CURRENT EXISTING 2ND BUILDING DEPARTMENT SUBMITTAL SET

ROUND BARN VILLAGE

SANTA ROSA, CA

BUILDING TYPE 100 | Roof Plan

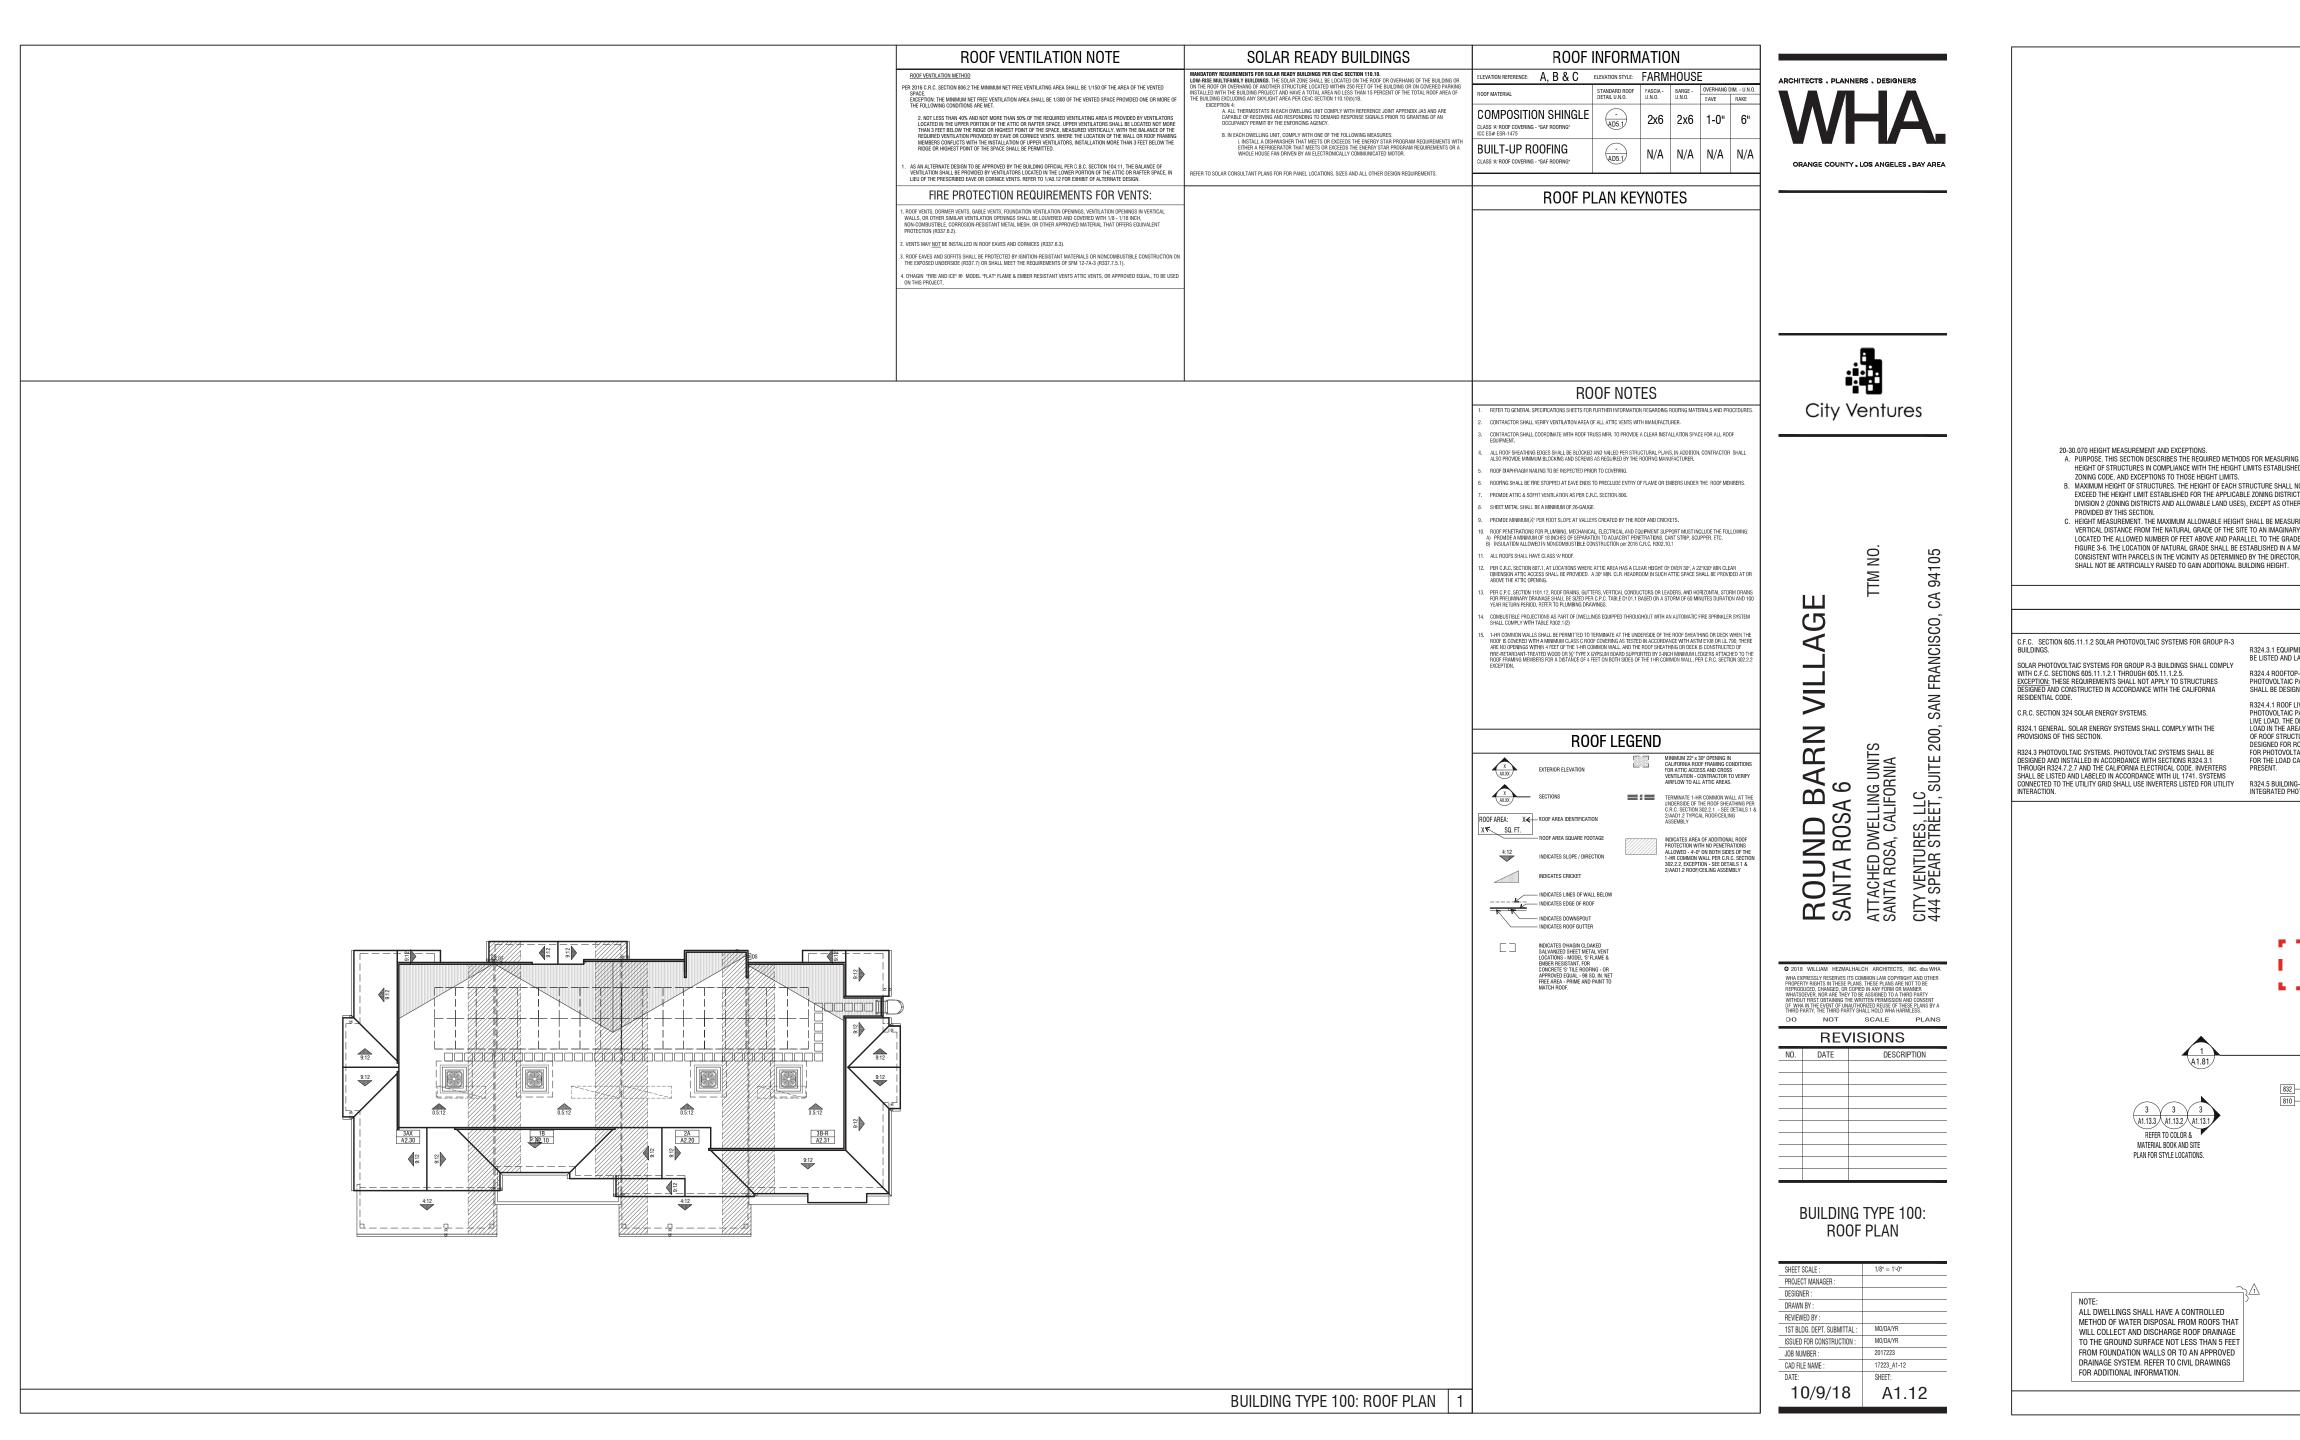
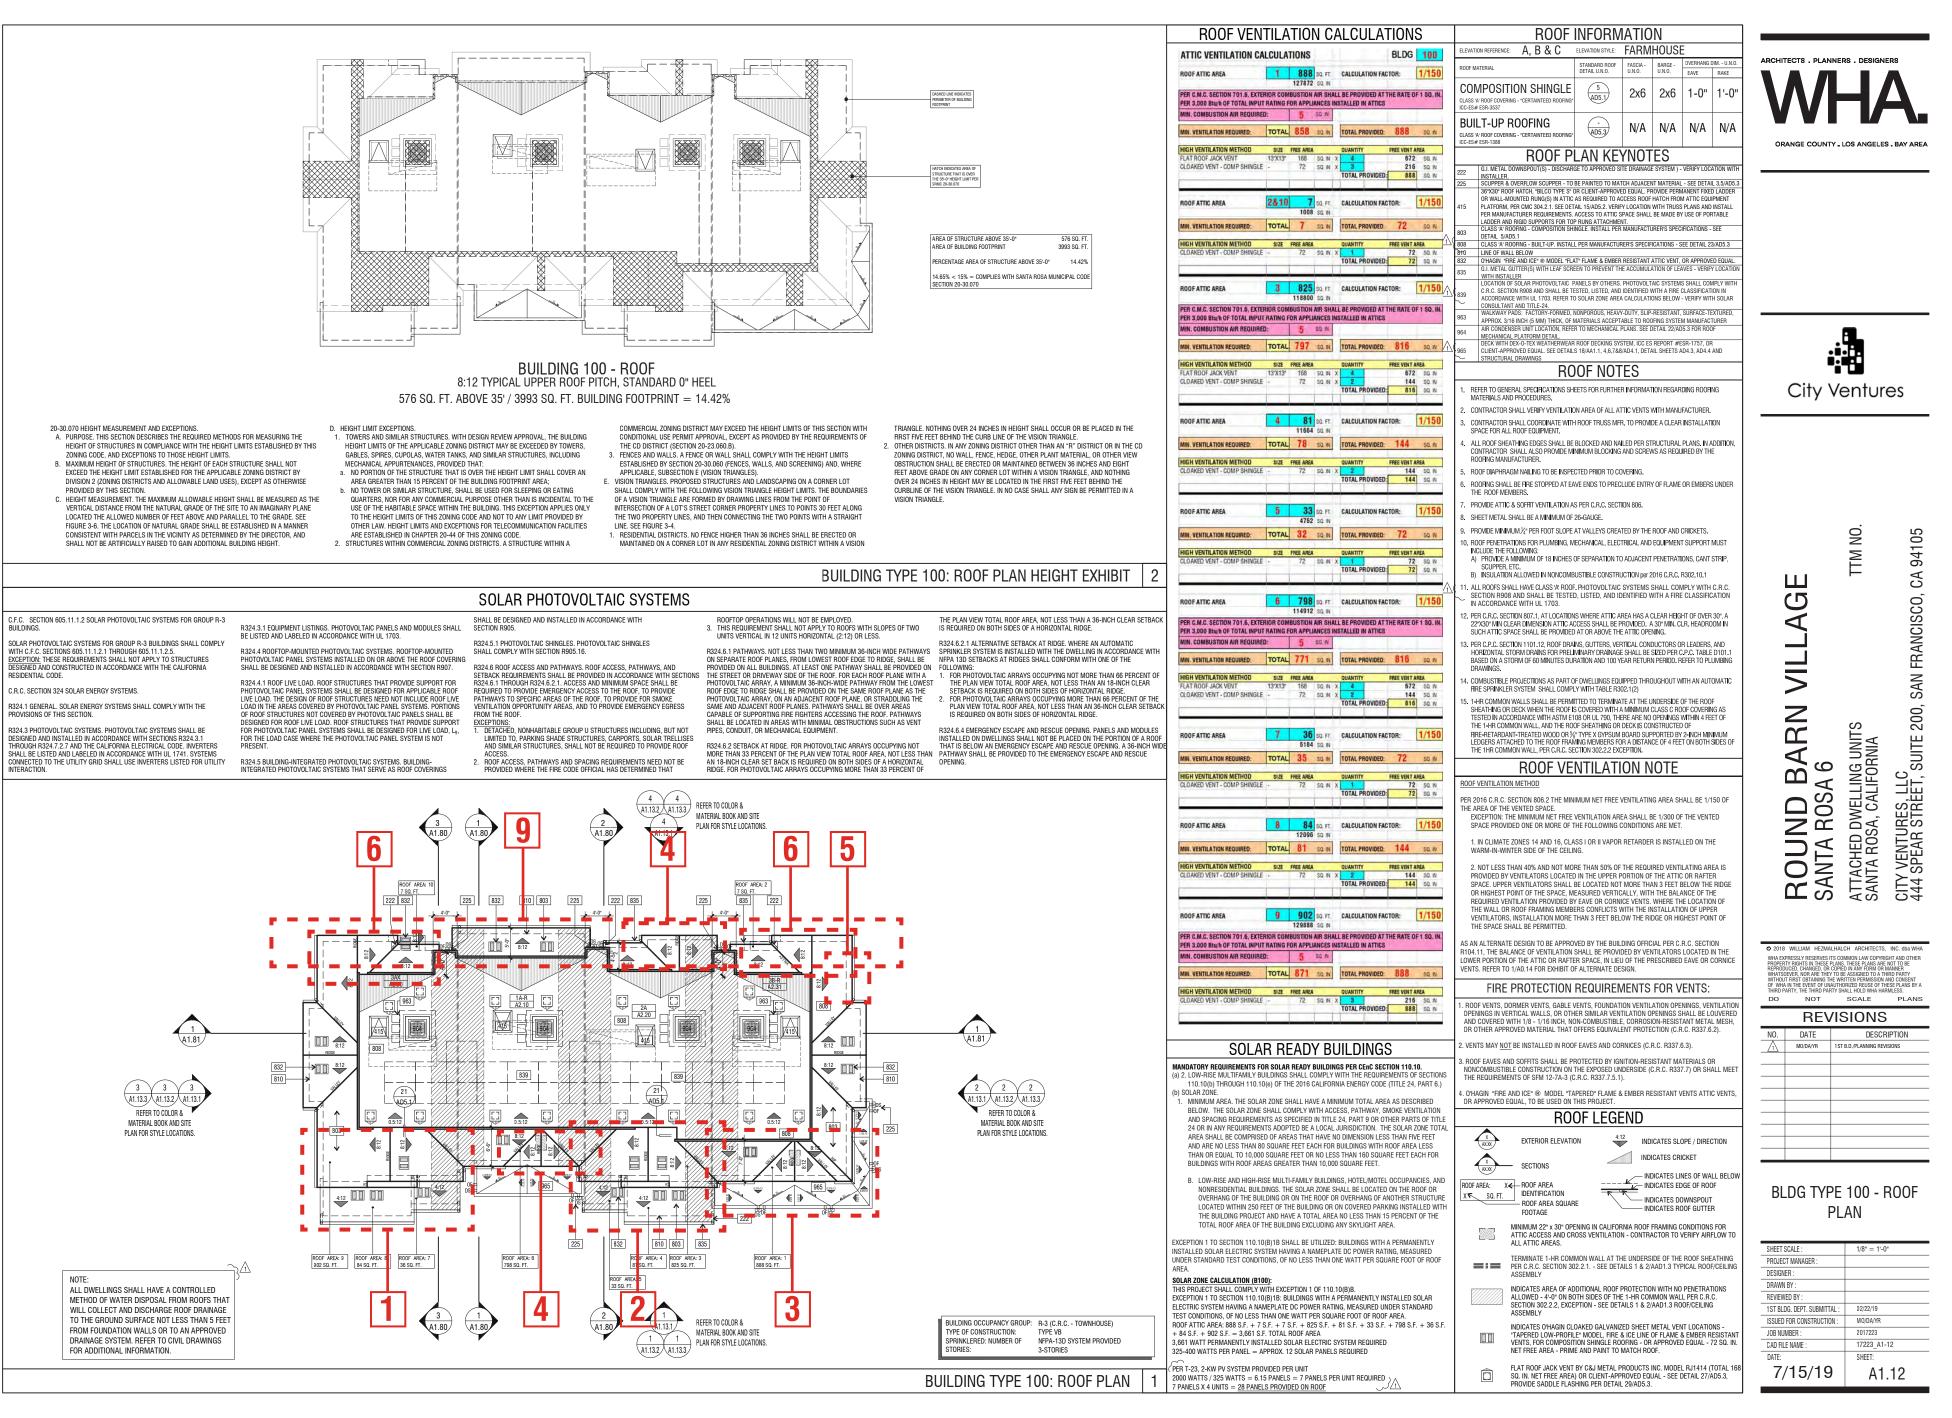
- 1 Unit 3A Added Covered Deck | Created Double Gable | Reconfigured Windows | Removed Awnings Above Windows | Removed / Replaced Horizontal Siding with Boards & Batts.
- 2 Unit 2A Added Covered Deck | Created Double Gable | Reconfigured Windows | Removed Awnings Above Windows | Removed / Replaced Horizontal Siding with Boards & Batts.
- 3 Unit 3B Added Wrap Around Deck / Reconfigured Porch | Added 3050 Window | Added Awning Above Deck Door and Windows at second level
- 4 Added Gable/Sloped Roof
- **5** Removed Ladder
- 6 Revised Second Floor Massing at Kitchen
- 7 Added Awning
- 8 Added Trellis at Unit 2A, Typ.

9 Per City Fire Request The Rear Elevation Roof Design Has Been Modified

BUILDING TYPE 100 | Style 1 Exterior Elevations

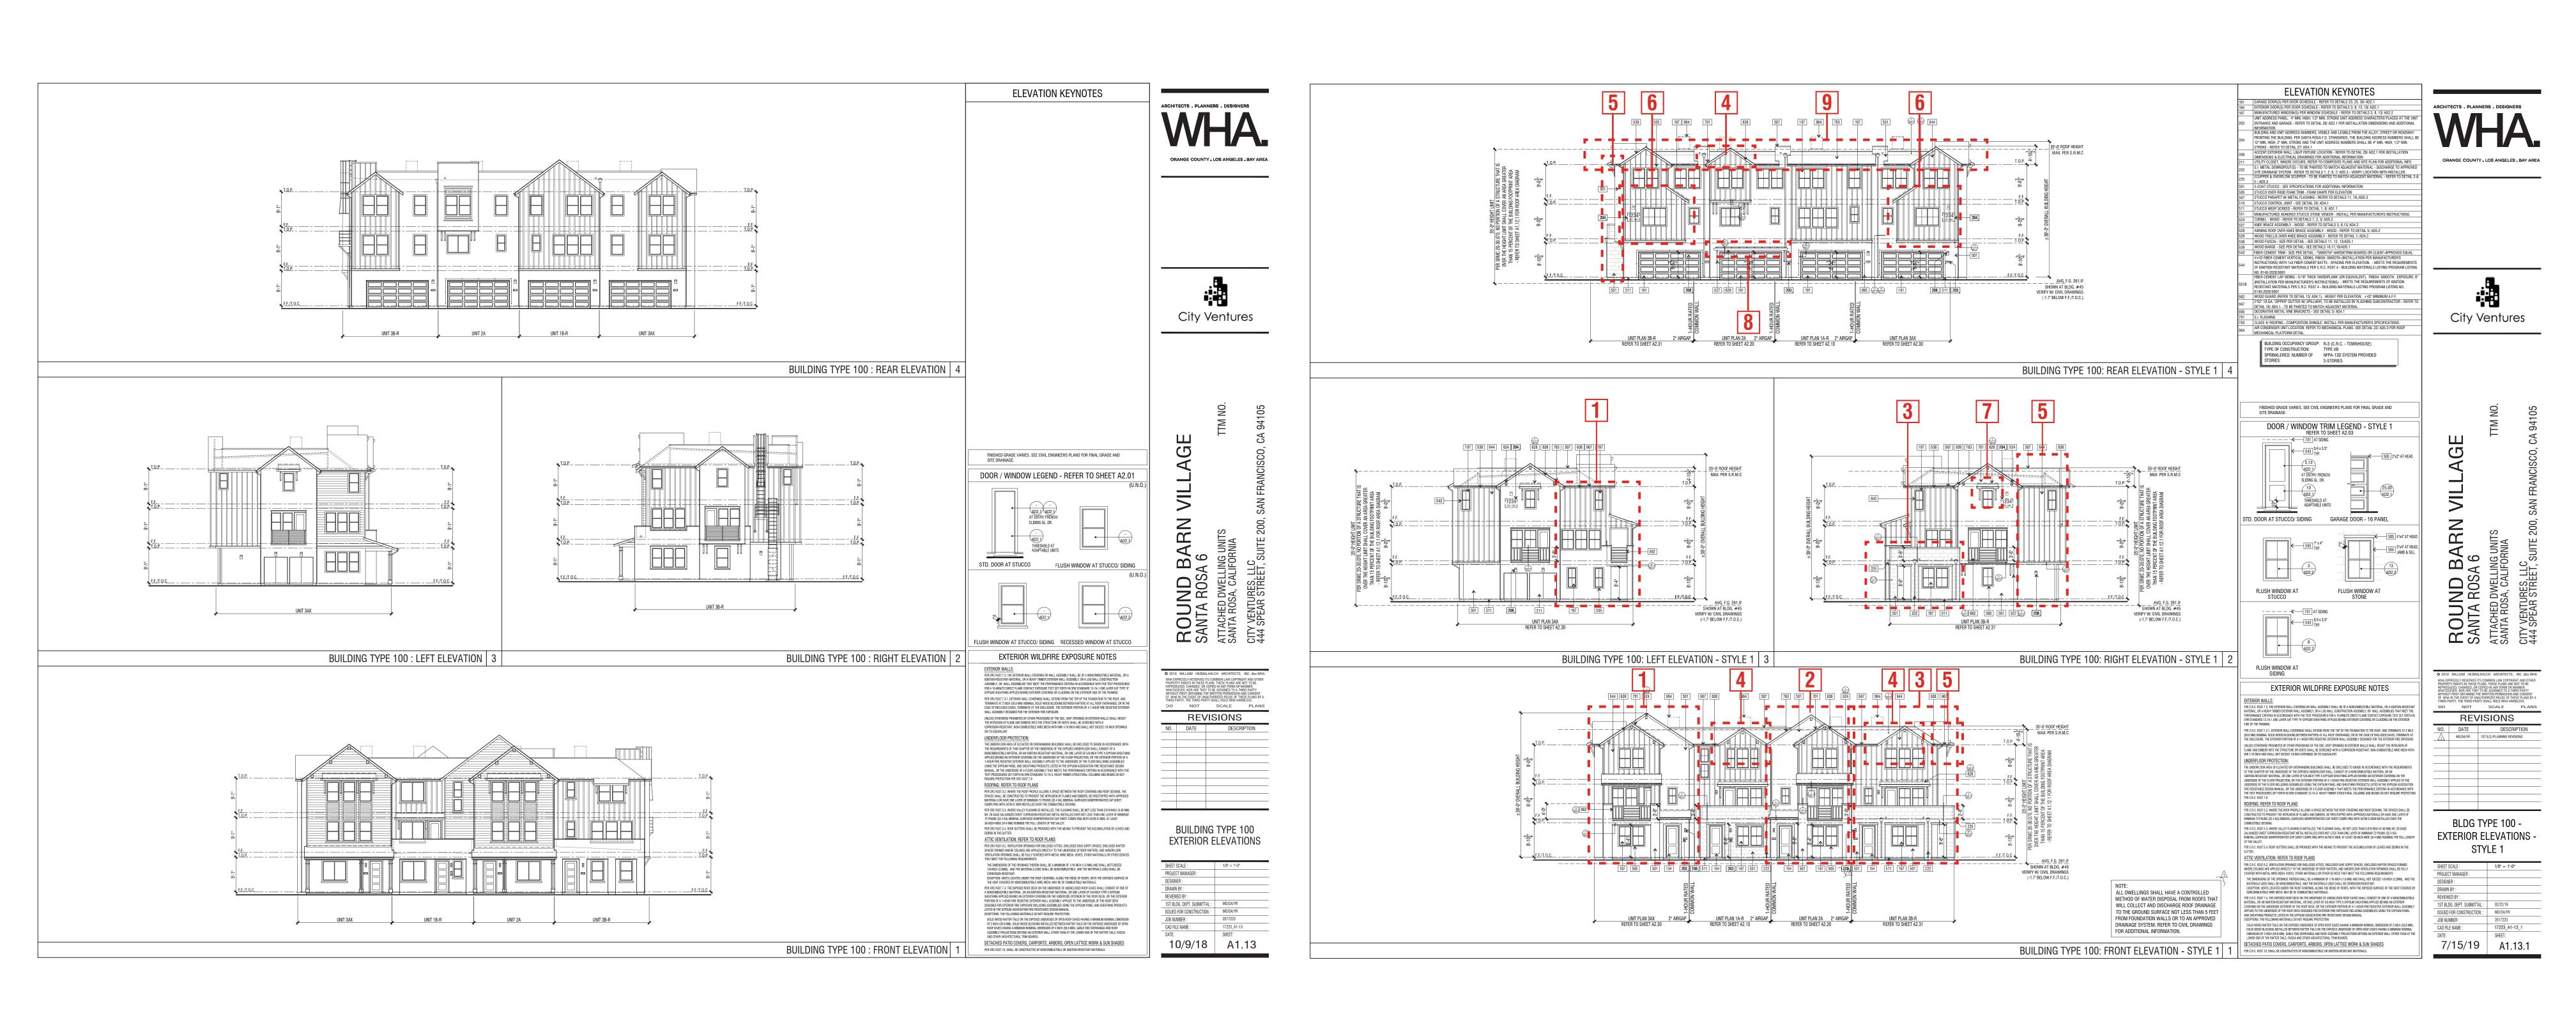
- 1 Unit 3A Added Covered Deck | Created Double Gable | Reconfigured Windows | Removed Awnings Above Windows | Removed / Replaced Horizontal Siding with Boards & Batts.
- 2 Unit 2A Added Covered Deck | Created Double Gable | Reconfigured Windows | Removed Awnings Above Windows | Removed / Replaced Horizontal Siding with Boards & Batts.
- 3 Unit 3B Added Wrap Around Deck / Reconfigured Porch | Added 3050 Window | Added Awning Above Deck Door and Windows at second level
- 4 Added Gable/Sloped Roof
- 5 Removed Ladder
- 6 Revised Second Floor Massing at Kitchen
- 7 Added Awning

8 Added Trellis at Unit 2A, Typ.
